2024 ISP Consumer Panel

Submission:

DRAFT 2023 Inputs, Assumptions and Scenarios Report

- Transmission Expansion Options Report (TEOR).

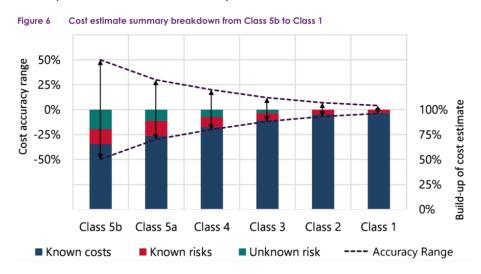
AEMO's approach in Figure 6 shows cost accuracy bands that differ from the AACE approach in two ways – the accuracy band is narrower and it is symmetrical.

This is confusing given any estimate of the 'total expected cost' of unknown risks is pure guess work. Why is a 30% risk factor for 'unknown risks' any more accurate than any other %? There is reference back to the GHG report in 2021 for the 2022 ISP where this figure first appeared and are used to justify the following accuracy bands:
